**Re: DG 14 - 233 Report on status of Repowering Concord Steam**

RE: Fire Marshal's Inspection Report, December 30, 2016  
Concord Steam Plant  
Concord, NH

Subject: Correction of Alleged Deficiencies Found During a State Fire Marshall Inspection

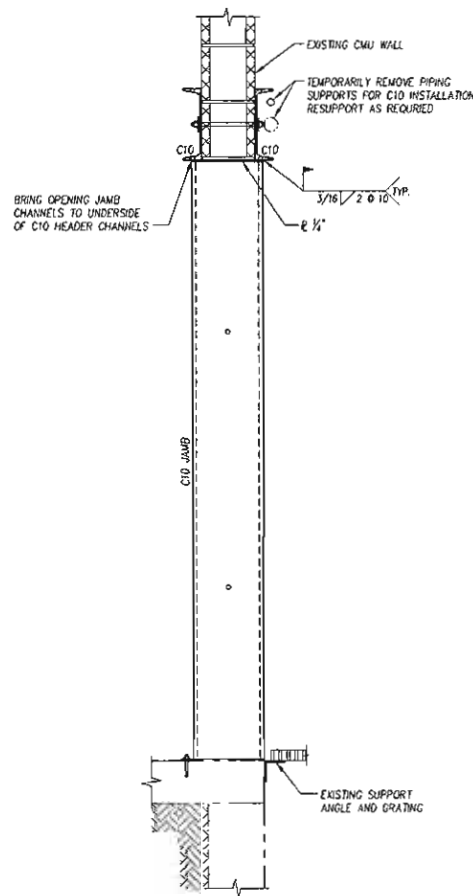
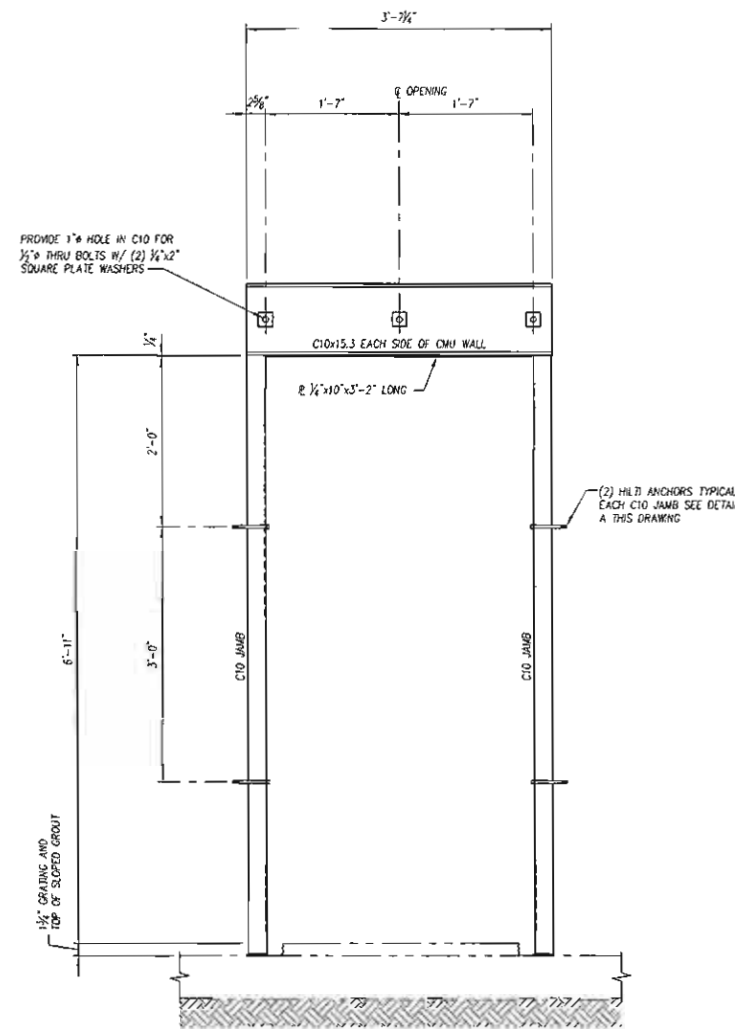
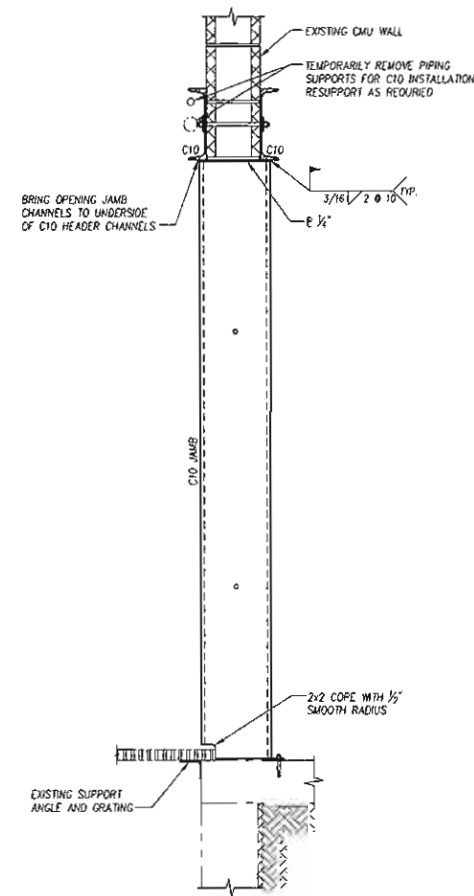
1. No header above man door leading from FD Fan Room to maintenance garage resulting in a crack in CMU wall above the door.

1. The man door opening cut through the hollow CMU wall has resulted in a crack above the header. We recommend installing a steel channel header above the door and steel channel door jambs on each side of the opening to support the header. This will provide support to the wall above the opening with no further danger of wall cracking. (see drawing S-100 for details.)

CONVEYOR WALL OPENING REINFORCEMENT PLAN  
SCALE: 3/4" = 1'-0"

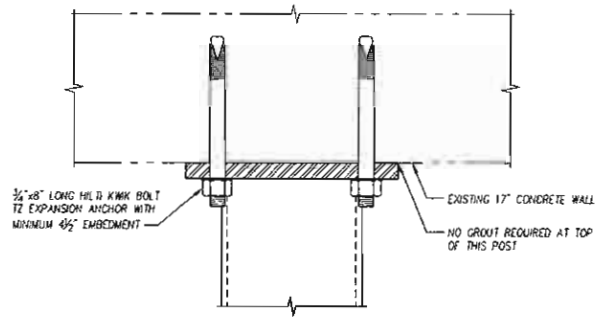
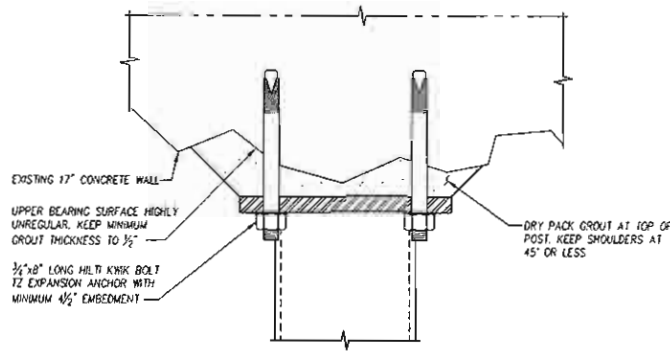
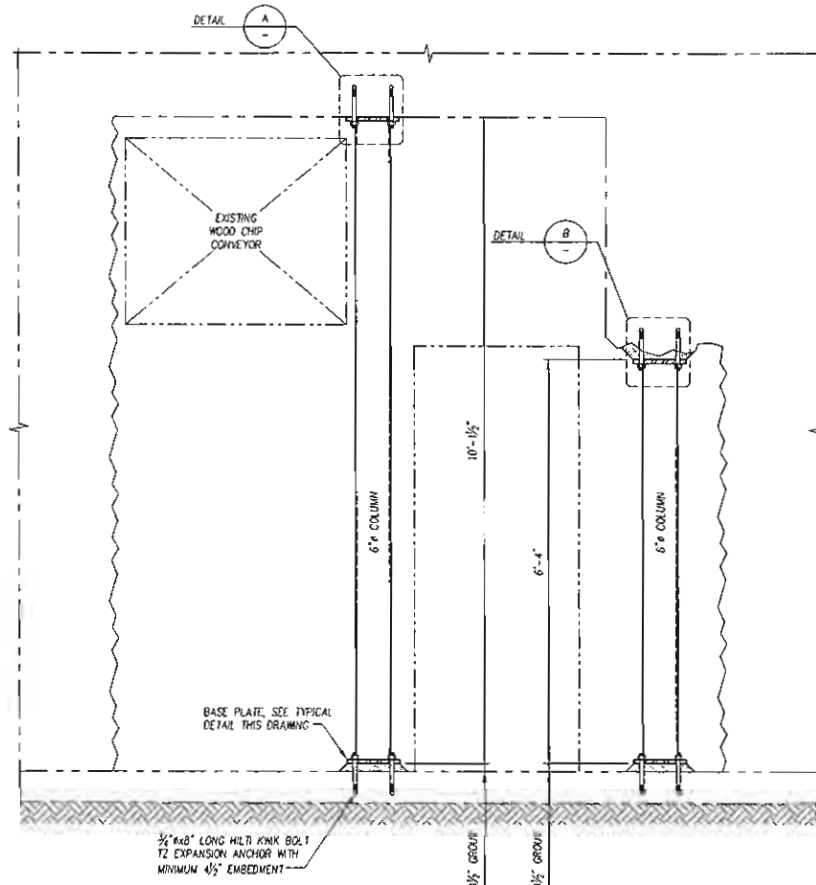
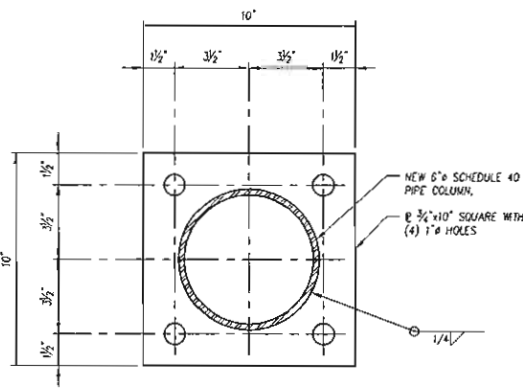
2. Large opening cut through 17" thick concrete bunker wall for chip conveyor to pass without means of support of wall above the opening.

2. The large opening cut into the 17" thick concrete coal bunker wall was done in 1979, with no damage above the opening occurring since then. However for added assurance that the wall above the opening will not suffer any damage we recommend installing two steel pipe columns from the floor slab to the underside of the openings. This will provide additional wall support and be sufficient to insure that the wall above will not move. (See drawing S-101 for details)

## METAL ROOF DECK REPAIR – TYPICAL DETAIL

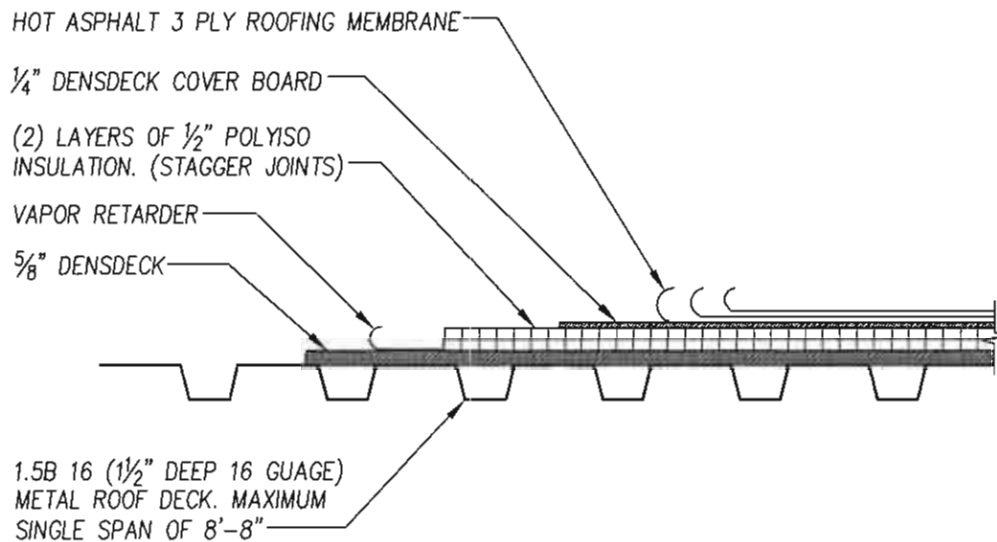
3. Deteriorated metal roof deck above Boiler

3. A portion of the metal deck which supports the built up roof over the boiler has deteriorated due to exposure to moisture. We understand that the roof surface, i.e., asphalt built up roof, will be repaired in the near future. We recommend stripping the roof material to expose the metal roof deck and replacing that portion of the deteriorated deck with new galvanized 1 1/2", 16 gage Type B deck prior to installing the new built up roofing. The deck should span from the masonry wall to the first line of trusses (approximately 7'-8") and then if further deterioration is found , installing the same size deck spanning from truss to truss (7'-10"). (See Sketch SK-1 for details)
